**DANE COUNTY DEPT. OF
PUBLIC WORKS, HIGHWAY &
TRANSPORTATION**

ADDENDUM

RFB NO. 317049 - ADDENDUM NO. 2

BIOGAS FACILITY CONSTRUCTION

SHEET NO.
C102
PROJECT NO.
170651

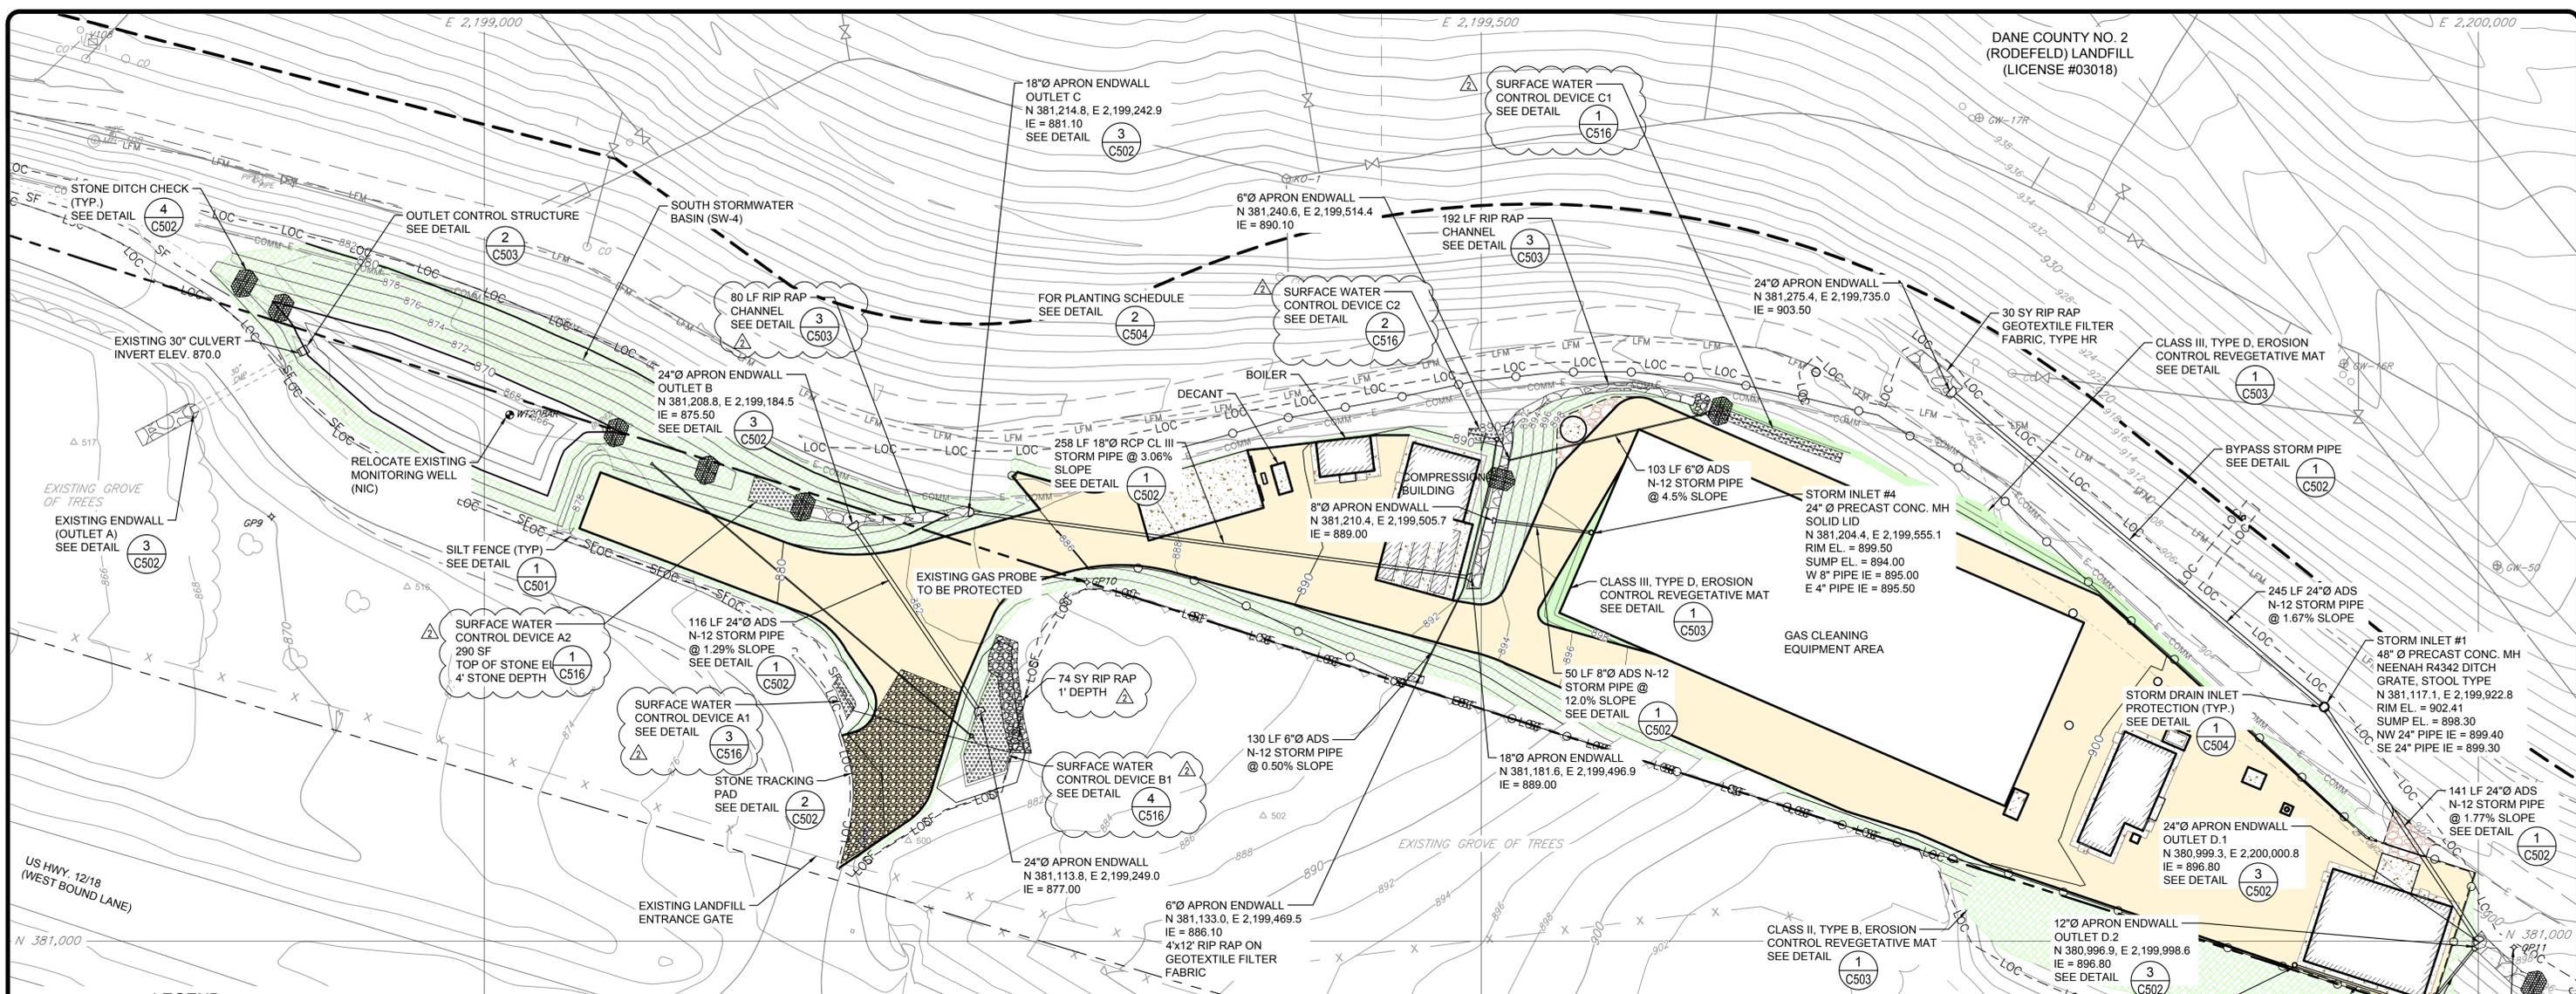
- 4. Sheet C102**
Updated to include concrete apron for Compressor Building overhead door.
- 5. Sheet C103**
Updated surface water control devices to meet requirements for oil and grease collection.

SHEET NO.
C121
 PROJECT NO.
 170651

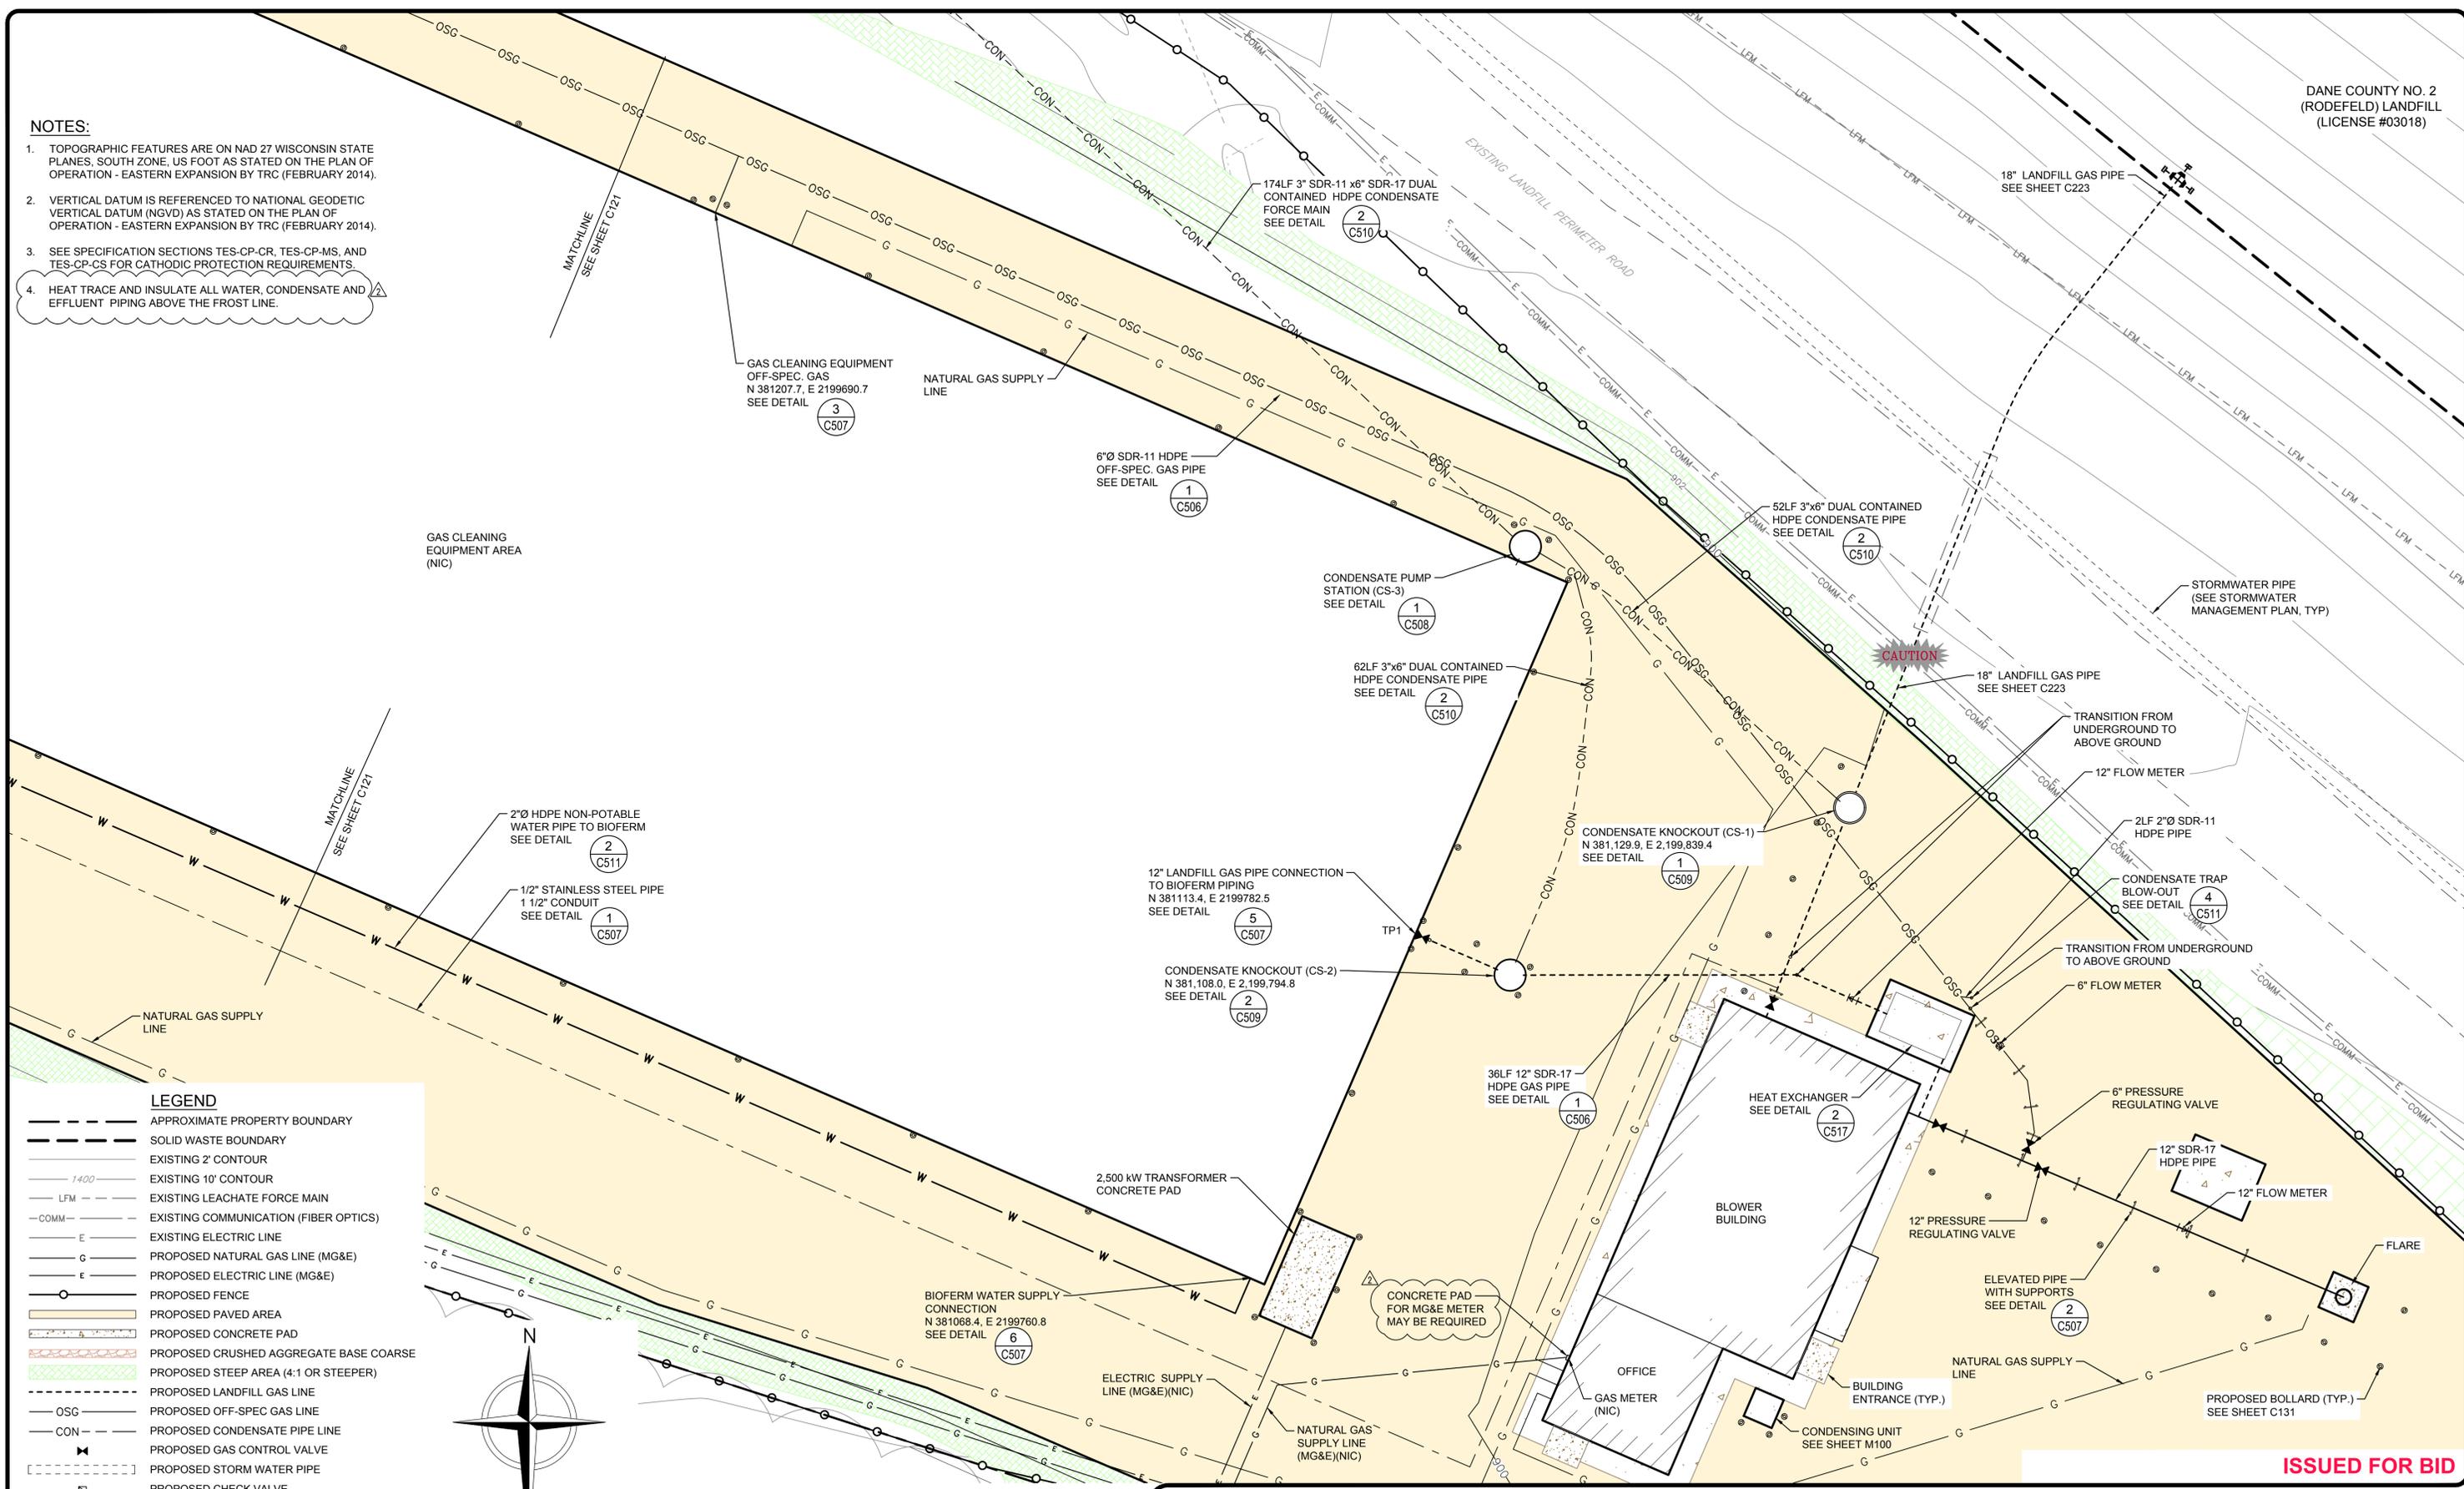
- 6. Sheet C121**
Updated to include a note that all water, condensate and effluent piping must be heat traced and insulated above the frost line.
- 7. Sheet C122**
Updated to include notes that all water, condensate and effluent piping must be heat traced and insulated above the frost line, and that a concrete pad for the MG&E natural gas meter may be required.

SHEET NO.
C122
PROJECT NO.
170651

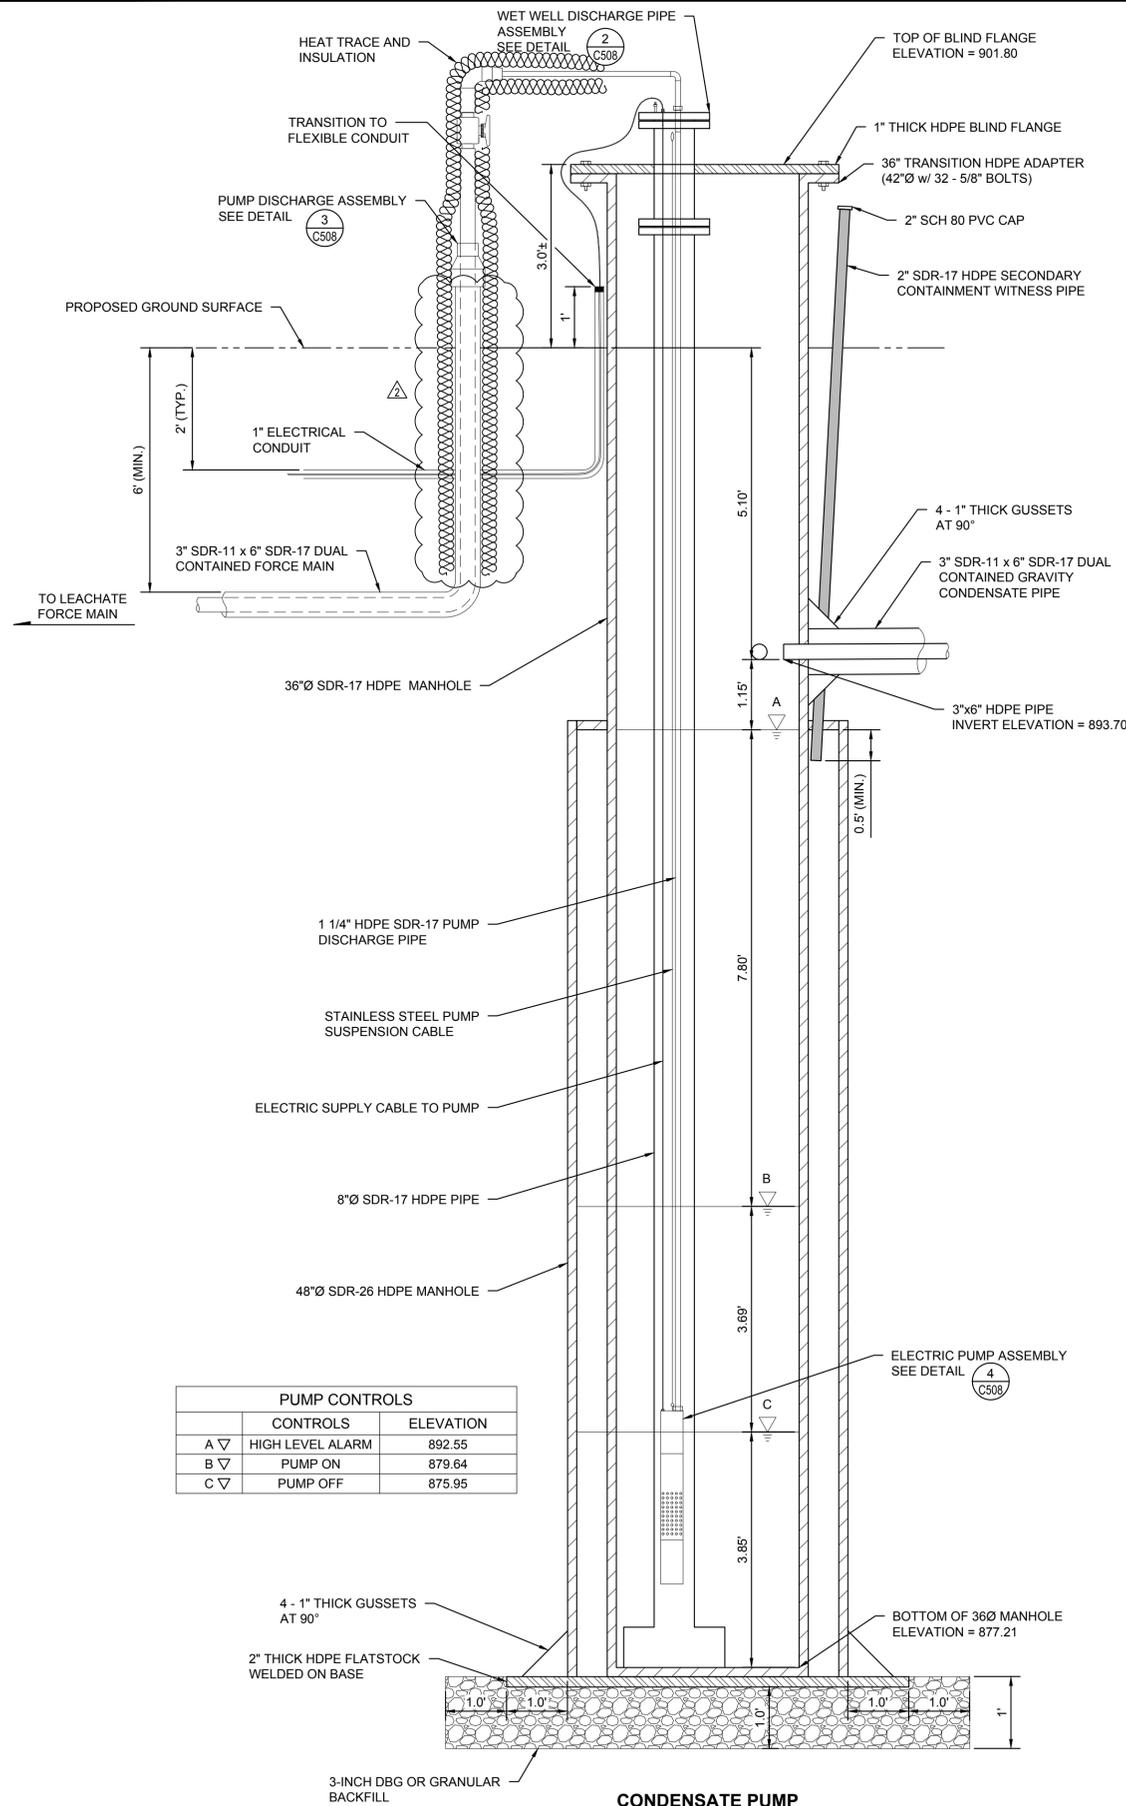
A14: *Sheet M101 has been revised to include the missing off spec gas piping and flow meters 5 and 6. Flow meter 7 can be found on Sheet C122 (6" flow meter adjacent to the heat exchanger).*
